Access Compliance Report

Public Rights-of-Way

(Curb Ramps)

Intersection ID: 13237	Main Street: W_PARK_AV	Cross Street: WILMORE_DR	Location: NW
ADA ID: 59B371931FA1	Ramp Type: PerpDiag	Initial Pass/Fail: Fail	Overall Compliance: No
Severity Score: 12.5			
Codes/Mitigation Info/Possible Solution		Field Measurements/Component Compliance

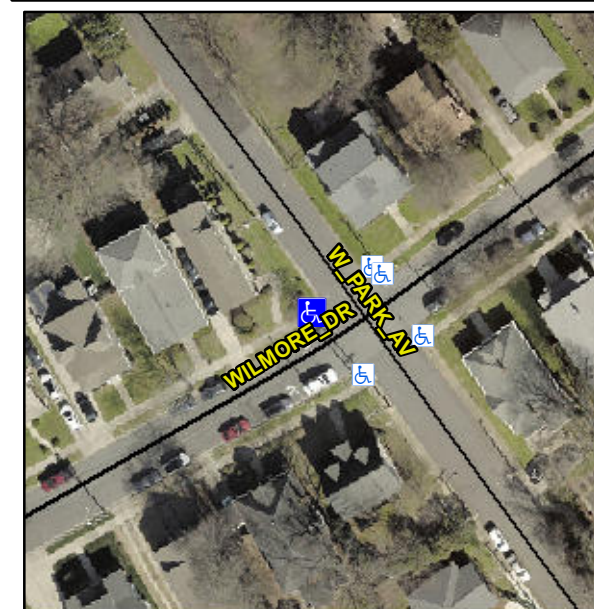
PROW/ADA:

Not Found, R304.5.3

Compliance	Description	Data	Compliance	Description	Data
N/A	Ramp Length (in)	45.0	Yes	Ramp Slope (%)	5.1
Yes	Ramp Width (in)	48.0	No	Ramp XSlope (%)	6.1
N/A	Flare Type LT	N/A	N/A	Flare Type RT	N/A
N/A	Flare Slope LT (%)	N/A	N/A	Flare Slope RT (%)	N/A
N/A	Flare Traversable LT?	N/A	N/A	Flare Traversable RT?	N/A
N/A	Landing Length (in)	N/A	N/A	DWS Provided?	N/A
N/A	Landing Width (in)	N/A	N/A	DWS Contrast?	N/A
N/A	Landing Slope (%)	N/A	N/A	DWS Length (in)	N/A
N/A	Landing X Slope (%)	N/A	N/A	DWS Full Width?	N/A
N/A	Landing Curb? (Y/N)	N/A	N/A	DWS Offset (in)	N/A
N/A	Shared Landing?	N/A			
N/A	Gutter Ponding?	N/A	N/A	Gutter Slope (%)	N/A
N/A	Gutter Lip Ht (in)	N/A	N/A	Gutter X Slope (%)	N/A
N/A	Painted X Walk1?	No	N/A	Painted X Walk2?	No
	X Walk 1 Direction	To SE		X Walk 2 Direction	To NE
N/A	X Walk 1 Width (in)	N/A	N/A	X Walk 2 Width (in)	N/A
	X Walk 1 Slope (%)	5.8		X Walk 2 Slope (%)	3.4
	X Walk 1 X Slope (%)	2.3		X Walk 2 X Slope (%)	1.8

Remove & Replace Curb Ramp With Two New Directional Ramps or Equivalent.
